In response to your requests dated March 22, 1976 and May 13, 1976, with supplement dated May 7, 1976, the Commission has issued the enclosed Amendment No. 23 to Facility Operating License No. DPR-44 for the Peach Bottom Atomic Power Station Unit No. 2.

PEACH BOTTOM ATOMIC POWER STATION, UNIT NO. 2

Amendment No. 23  
License No. DPR-44

ATTACHMENT TO LICENSE AMENDMENT NO. 23

Figure 3.5.1.F Maximum Average Planar Linear Heat Generation Rate Versus Planar Average Exposure

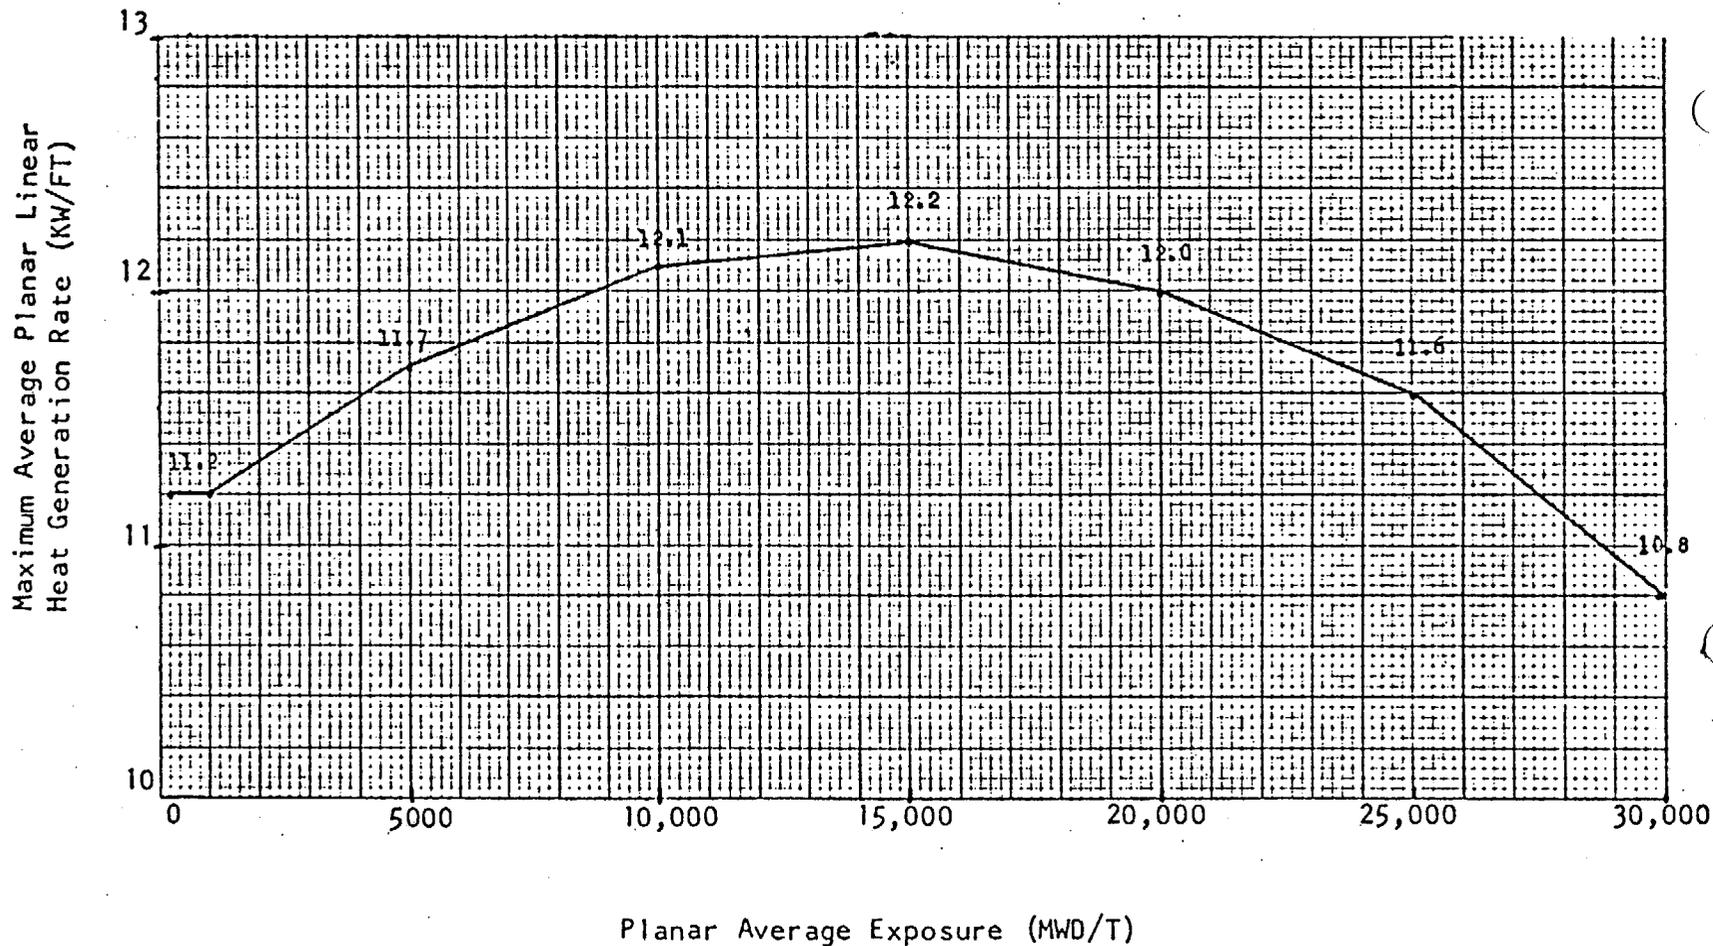
The loss-of-coolant accident was reanalyzed for the Reload 1 8 x 8 fuel with 100 mil channels and for the LTA's; the results are presented in References 2 and 4. The analyses showed compliance with the criteria in 10 CFR Section 50.46 and Appendix K of 10 CFR Part 50. The Technical Specification changes (Reference 7) which were submitted include new MAPLHGR curves for the 8 x 8 fuel (Figure 3.5.1.F) and the LTA fuel (Figure 3.5.1.G) applicable to fuel Cycle 2.

During steady state power operation, the APLHGR for each type of fuel as a function of average planar exposure shall not exceed the limiting value shown in Figure 3.5.1-A, 3.5.1-B, 3.5.1-F, 3.5.1-G, as applicable. If at any time during steady state operation it is determined by normal surveillance that the limiting value for APLHGR is being exceeded, action shall then be initiated to restore operation to within the prescribed limits. Surveillance and corresponding action shall continue until the prescribed limits are again being met.
